SR 92 Widening and Reconstruction from the Northpoint Parkway to the Cherokee Trail

Value Engineering Study Report

Final Design Development

re: Project Numbers NH-165-1 (40), Widening of State Route 92 from Woodland Road to Cherokee Trail and NH-165-1 (42), State Route 92 Widening from Northpoint Parkway to Woodland Drive in Cherokee County, Georgia
Value Engineering Study Report

B-1 (42)

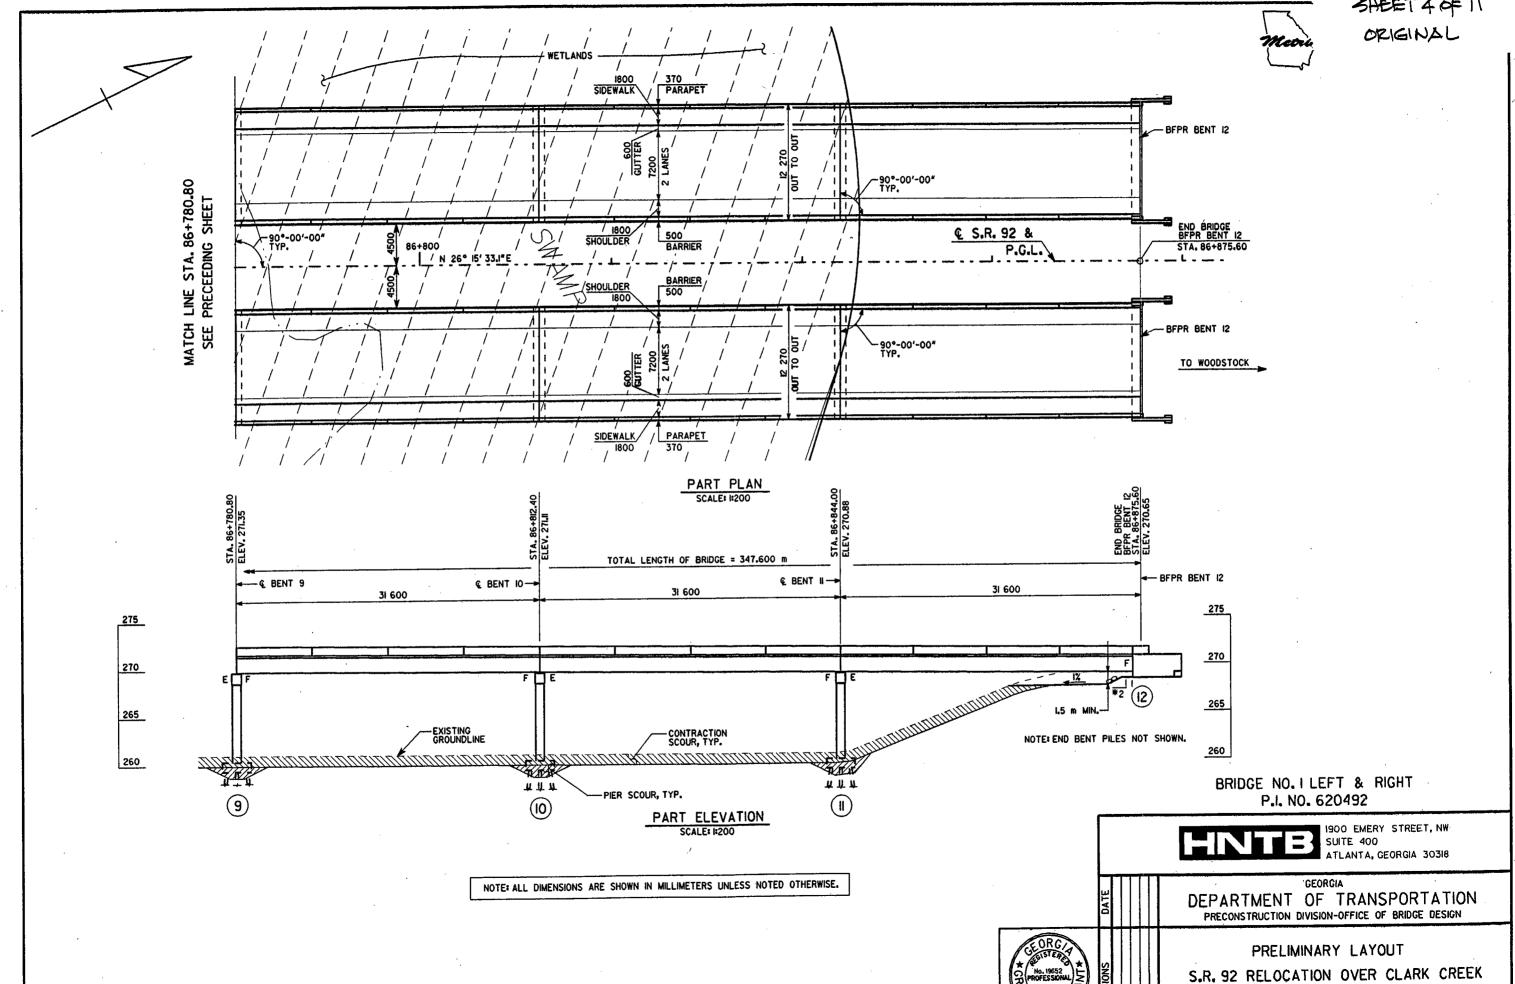
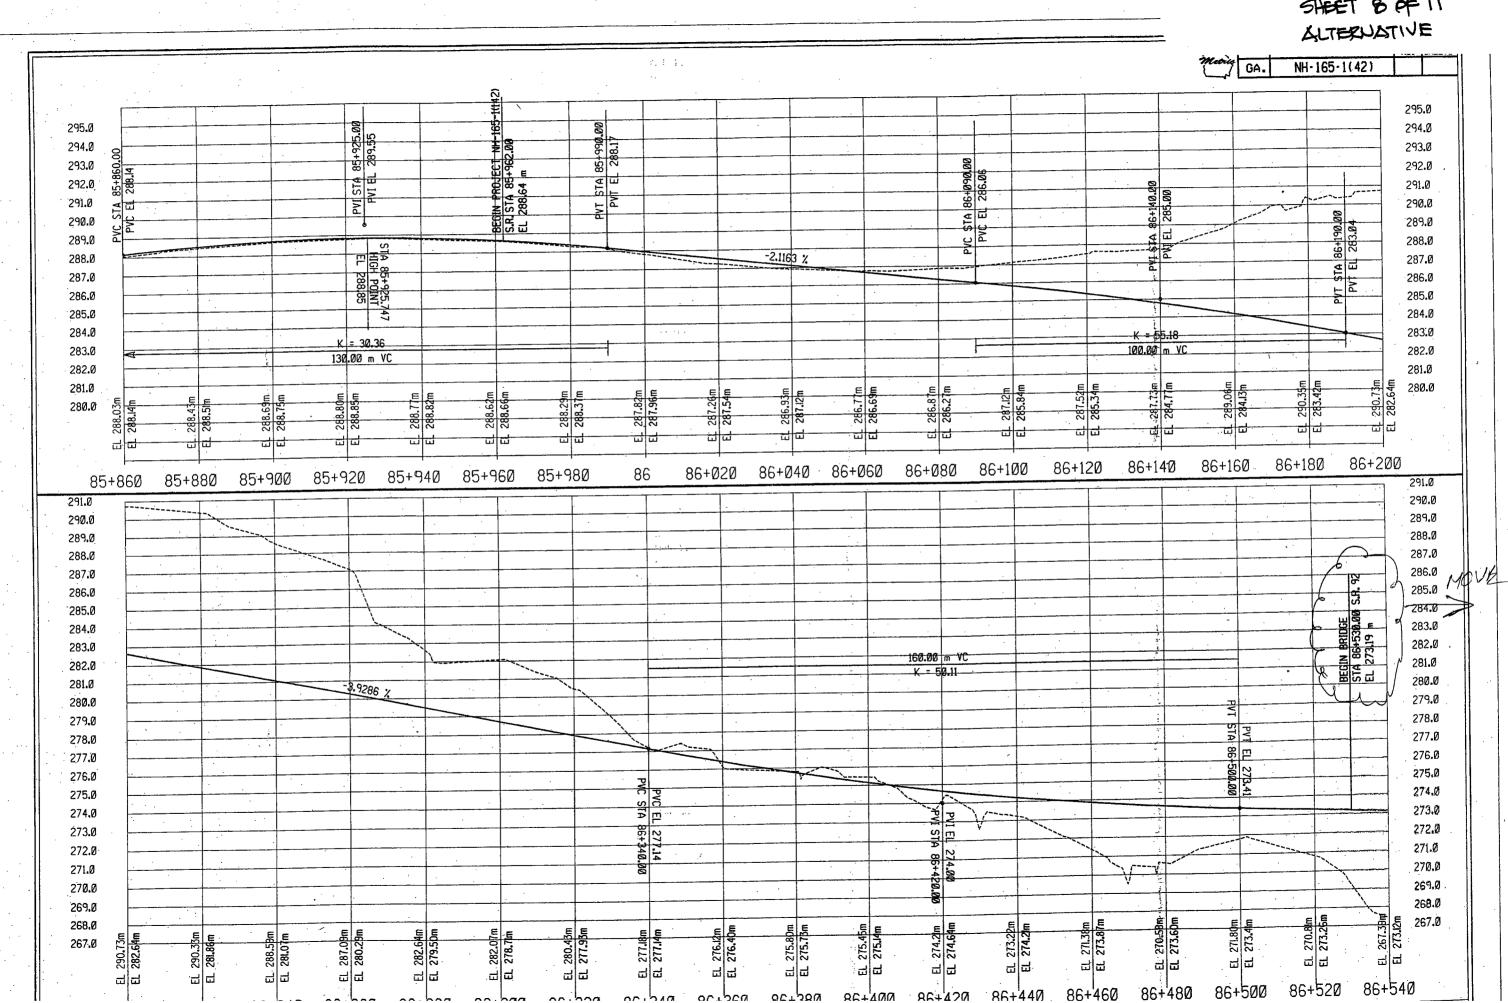
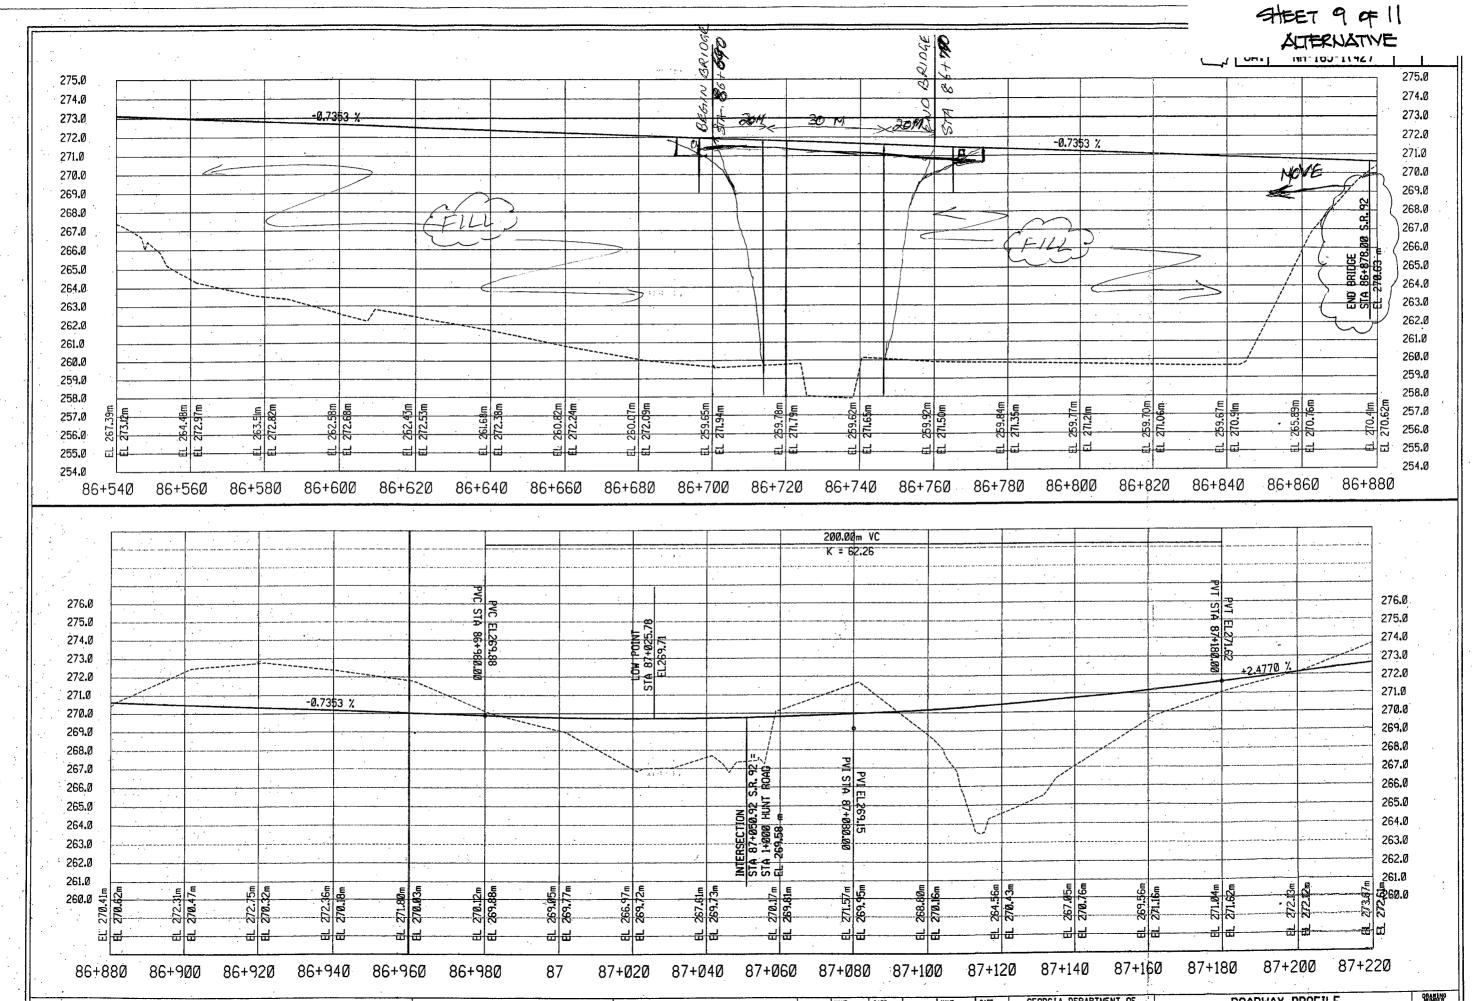
The current design calls for the use of two, 2-lane bridge structures to span Clark Creek on the new alignment. One bridge will accommodate eastbound traffic and the second bridge will accommodate westbound traffic. The existing culvert crossing of Clark Creek is to be abandoned.

The original 347.600 meter bridge can be shortened by approximately 275 meters by spanning over the creek only. The remaining length could be filled (embankment) with material borrowed from the abandoned alignment of SR 92 over Clark Creek.

Along the new alignment, provide embankment approaches to shortened bridges spanning Clark Creek. Use the existing embankment of Clark Creek as the fill material for the new approaches.

B-2 (42), et. al.

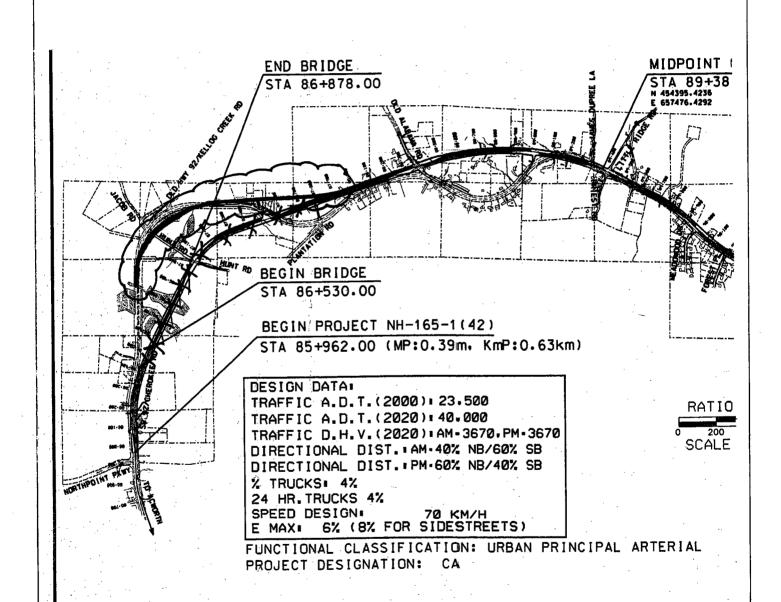
The current design calls for a symmetrical alignment throughout the length of the project with new crossings, left turn lanes, and improved accessibility.

This alternative maintains the current/existing roadway alignment at Clark Creek crossing and will provide for a conventional roadway widening along the existing alignment. The drawback of this scheme is that a larger area of the wetlands will be disturbed, filled-in as opposed to spanning. However, it mimics existing conditions more closely. If the Corps of Engineers is requiring that the existing opening be maintained to prevent flooding, then this alternative continues the philosophy. This alternative basically trades off the bridge costs for remediation of the wetlands. Another benefit would be the salvation of more of the existing roadway.

Maintain the existing SR 92 alignment and culvert at the west end of the project; extend the culvert and construct parallel roadway next to existing alignment. Realign remainder of SR 92 to Old Alabama Road.

B-H (H2) ORIGINAL DESIGN

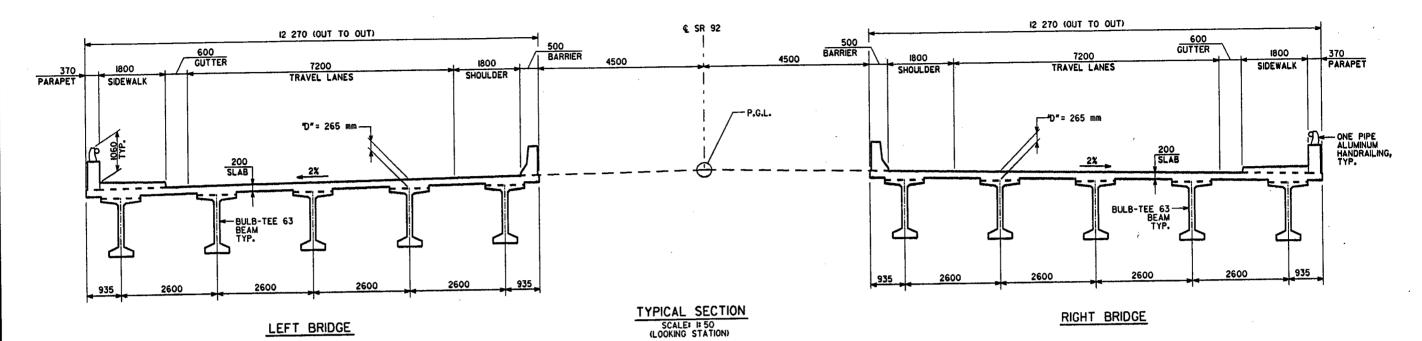
As noted on the calculation sheet, a more refined cost analysis would show cost savings due to the elimination of the inside barrier rails, and possibly one column per bent and associated footings and piles.

Along the new alignment, provide a single bridge structure accommodating four lanes with sidewalks on both sides. Eliminate the median.
